PERMIT

SEWAGE DISPOSAL SYSTEM

MARYLAND STATE DEPARTMENT OF HEALTH

SITE INSPECTION SHEET

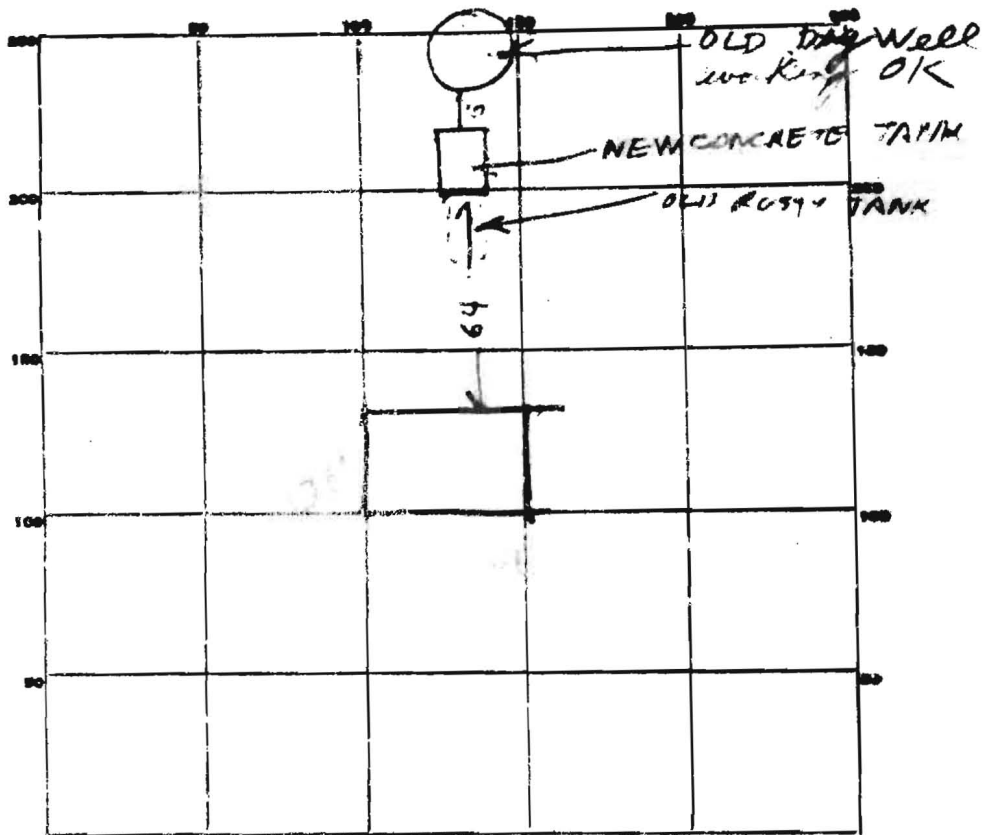
SEPTIC TANK, LEVEL OK concrete 1000 CLEANOUTS OK
Top is 4 FT below grade

REMARKS 8/19/66 - Old metal tank rusted out
in 10 years. Don't know brand. Tank was
not covered with tar like most metal tanks.
Water well in front yard.

LOCATION DIAGRAM

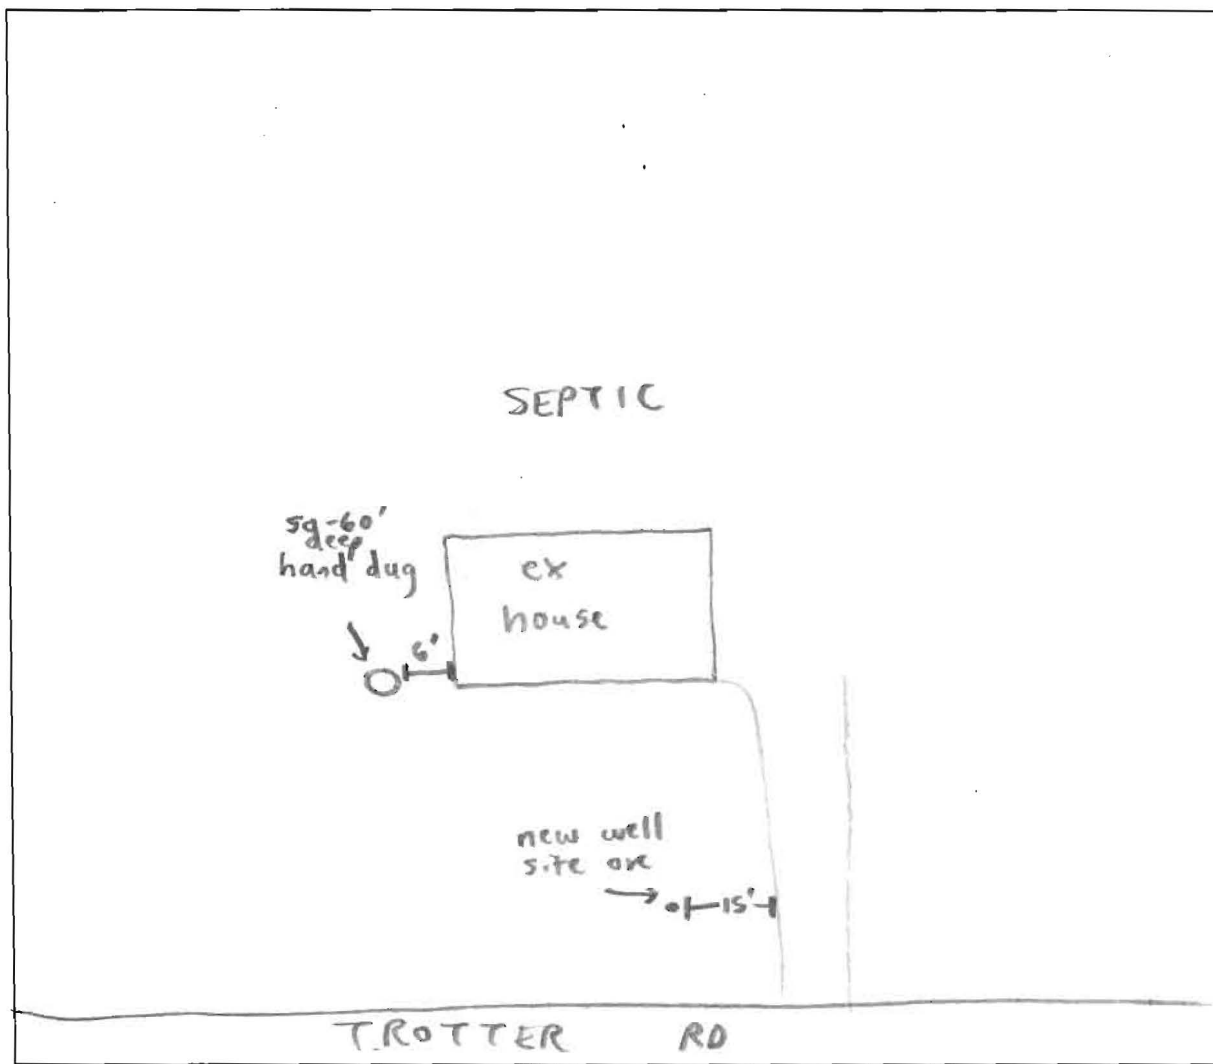
COMMENTS: OLD HAND DUG HAS LOW FLOW. NEW WELL SITE OK.
Verified surrounding well & septic within 100'. SPECIAL
CONDITIONED WELL PERMIT DUE TO GEOLOGIC
CONDITIONS.
